**LANDMARK COMMISSION****JUNE 1, 2026**

FILE NUMBER: COA-26-000183  
LOCATION: 3503 Meyers St.  
STRUCTURE: Contributing  
COUNCIL DISTRICT: 7  
ZONING: PD-595

**REQUEST(S)**

A Certificate of Appropriateness for exterior rehabilitation of main building to include window replacement (total 20) and enclosure, and exterior siding replacement.

#### Enclosure – Window 7 (Cornerside Elevation)

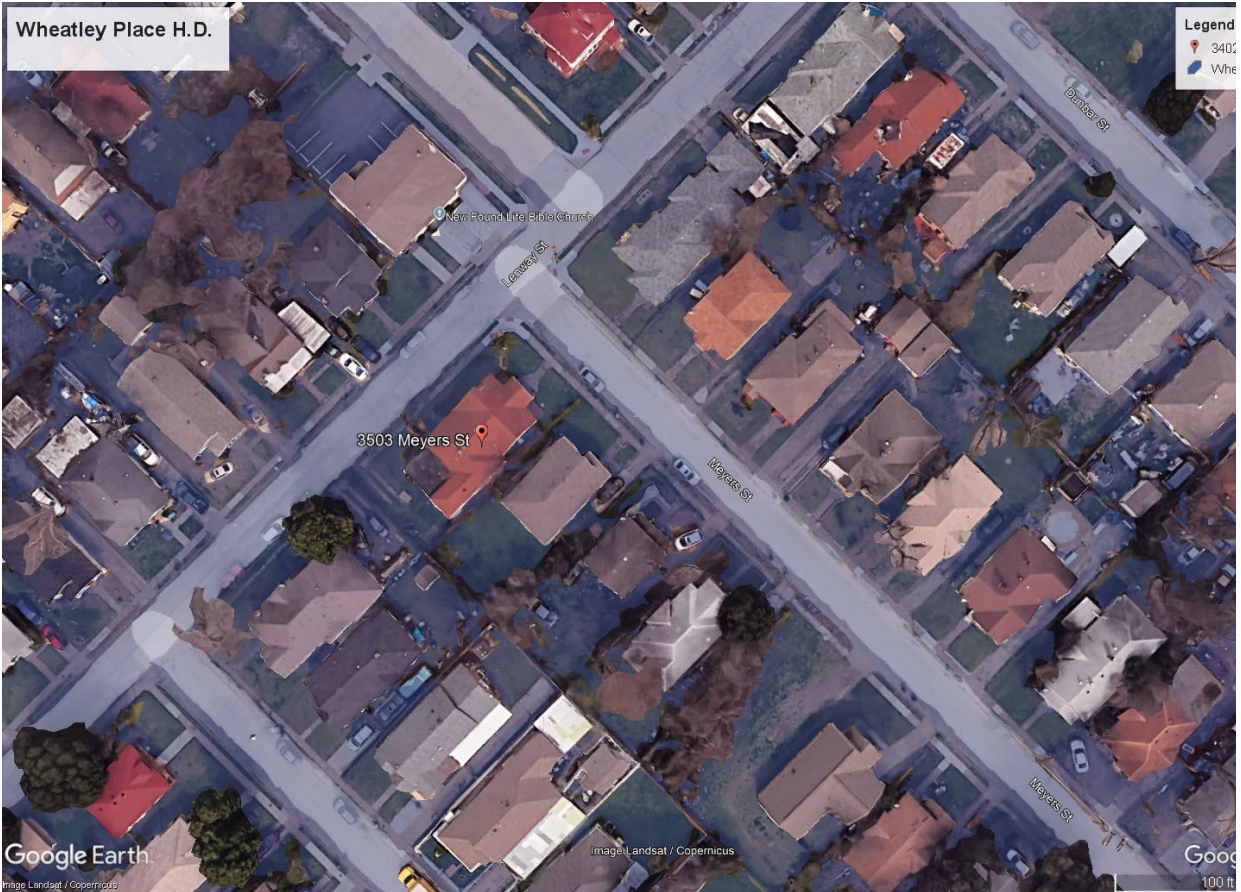
As clarified in the application materials and the Window Survey, the applicant proposes to enclose the paired window unit labeled “Window 7”, located on the cornerside (right) elevation. This elevation is a protected façade under the Wheatley Place Historic District ordinance, which specifies that front, cornerside, and interior side facades of contributing structures are protected and that their historic solid-to-void ratios must be maintained. Alterations to protected facades must retain the historic openings, preserve architectural features, and employ materials compatible with the historic appearance.

The applicant states that the purpose of enclosing Window 7 is to create additional wall space for upper-level kitchen cabinets. While interior functional needs may warrant reconfiguration, the Secretary of the Interior's Standards discourage the removal or enclosure of intact windows where they contribute to the building's historic character, and the district criteria prohibit altering historic openings on protected façades except where deterioration necessitates replacement.

Because Window 7 is intact and located on a protected elevation, enclosing it would eliminate a historic opening, alter the historic solid-to-void ratio, and adversely impact the architectural character of the structure. Staff therefore finds the enclosure inconsistent with the Wheatley Place Preservation Criteria and the Secretary of the Interior's Standards.

To address the applicant's storage needs without compromising protected historic fabric, staff recommends the following alternatives:

- **Reconfigure Cabinet Layout**  
Utilize alternative wall segments in the kitchen for upper cabinets to retain the historic window opening(s).
- **Use Shallow Cabinets or Open Shelving**  
Provides storage capacity while preserving window visibility and preventing enclosure.
- **Install Base Cabinets Only Beneath the Window**  
Maintains functional workspace without interfering with the window unit.
- **Integrate Window(s) into Kitchen Design**  
Treat the window(s) as a design element supporting daylighting, providing aesthetic value while maintaining historic integrity.

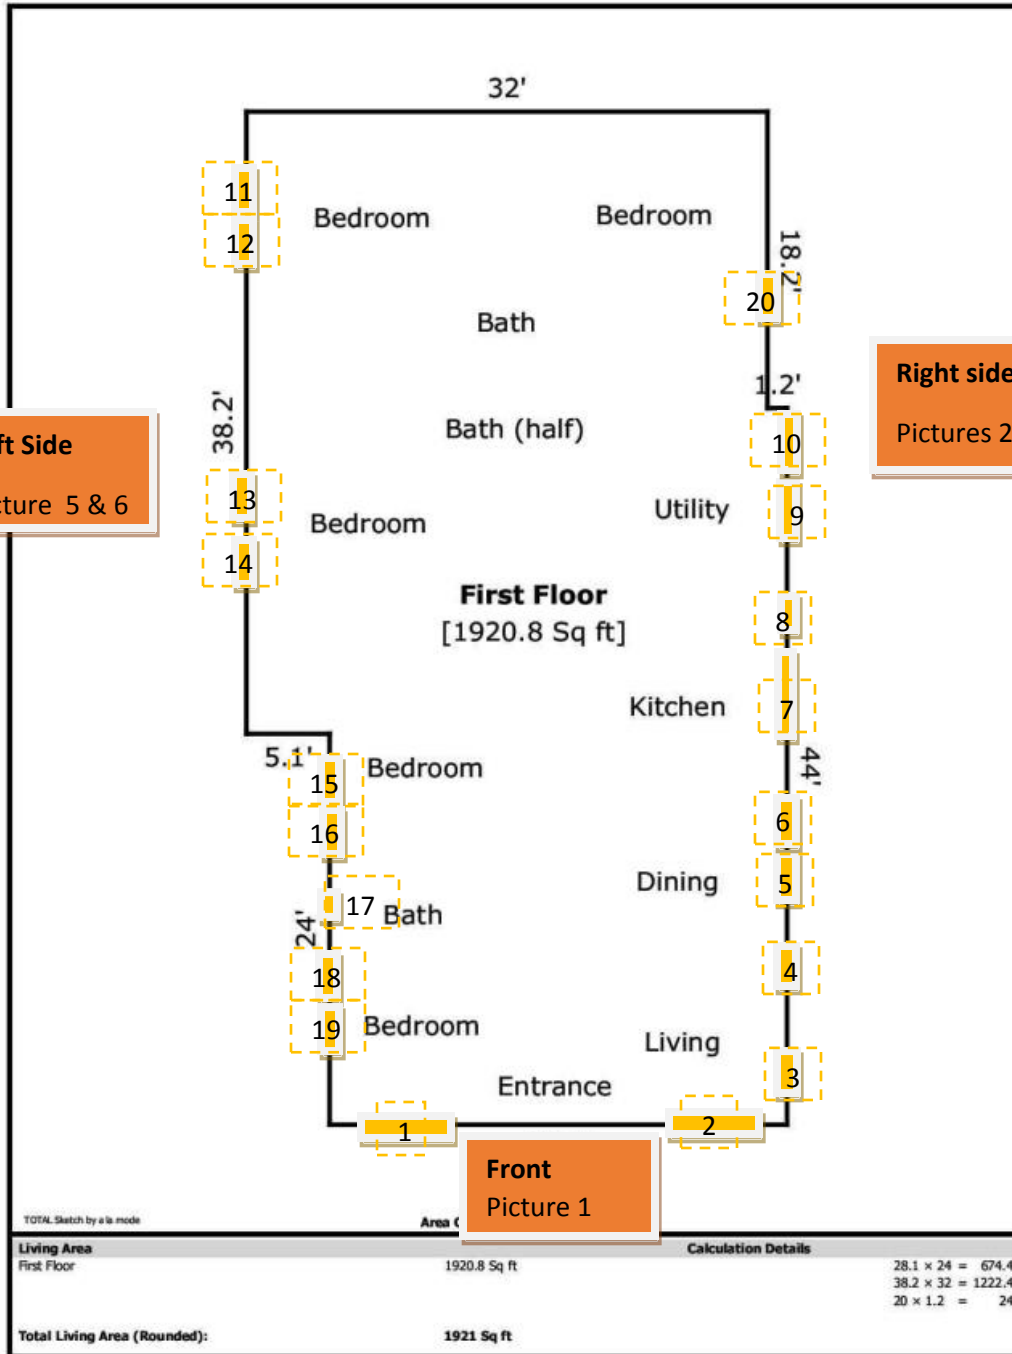
We are requesting approval to **cancel/remove nine (9) existing windows**. This request is based on:

## B. Right Side of the House (5 Windows Total)

### 2. Kitchen Area – 3 Windows (38" x 30")

- These three small windows are located on the right side toward the rear.
- Removing them will allow us to build a **functional kitchen layout**, including wall cabinets and proper appliance placement.
- These windows are not original and do not contribute to the historic façade.
